Access Compliance Report

Public Rights-of-Way

(Curb Ramps)

Intersection ID: 10014099	Main Street: W W T HARRIS BV	Cross Street: N/A	Location: W
ADA ID: D8623F84E918	Ramp Type: ParaDiag	Initial Pass/Fail: Fail	Overall Compliance: No
Codes/Mitigation Info/Possible Solution		Field Measurements/Component Compliance	
Severity Score: 13.75

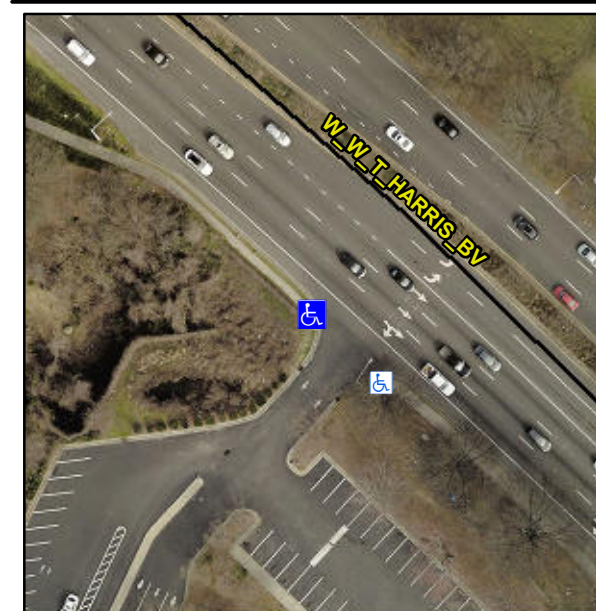
MEDIAN ACROSS W W T HARRIS BV

Compliance	Description	Data	Compliance	Description	Data
N/A	Ramp Length LT (in)	40.0	N/A	Ramp Length RT (in)	50.0
Yes	Ramp Width LT (in)	60.0	Yes	Ramp Width RT (in)	60.0
Yes	Ramp Slope LT (%)	1.3	No	Ramp Slope RT (%)	8.9
No	Ramp XSlope LT (%)	2.3	No	Ramp XSlope RT (%)	3.9
N/A	Landing Length (in)	N/A	N/A	DWS Provided?	N/A
N/A	Landing Width (in)	N/A	N/A	DWS Contrast?	N/A
N/A	Landing Slope (%)	N/A	N/A	DWS Length (in)	N/A
N/A	Landing X Slope (%)	N/A	N/A	DWS Full Width?	N/A
N/A	Landing Curb? (Y/N)	N/A	N/A	DWS Offset (in)	N/A
N/A	Shared Landing?	N/A			
N/A	Gutter Ponding?	N/A	N/A	Gutter Slope (%)	N/A
N/A	Gutter Lip Ht (in)	N/A	N/A	Gutter X Slope (%)	N/A
N/A	Painted X Walk1?	No	N/A	Painted X Walk2?	No
	X Walk 1 Direction	To SE		X Walk 2 Direction	To NE
N/A	X Walk 1 Width (in)	N/A	N/A	X Walk 2 Width (in)	N/A
	X Walk 1 Slope (%)	3.6		X Walk 2 Slope (%)	10.2
	X Walk 1 X Slope (%)	7.3		X Walk 2 X Slope (%)	0.9
N/A	Ramp inside XWalk1?	N/A	N/A	Ramp inside XWalk2?	N/A

Road Slope (%)	2.4	N/A	Clear Space?	N/A
	Road X Slope (%)	6.6	N/A	Clear Space to XWalk (in)	N/A
N/A	Any Obstructions?	N/A	N/A	Storm Grate/Utility Hazard?	N/A
	Obstruction Type			Storm Grate/Utility Type	
		N/A			N/A
			Yes	Surface Condition? (G/P)	Good
			N/A	Curb Slope (%)	0.9

Remove & Replace Curb Ramp With Two New Directional Ramps or Equivalent.
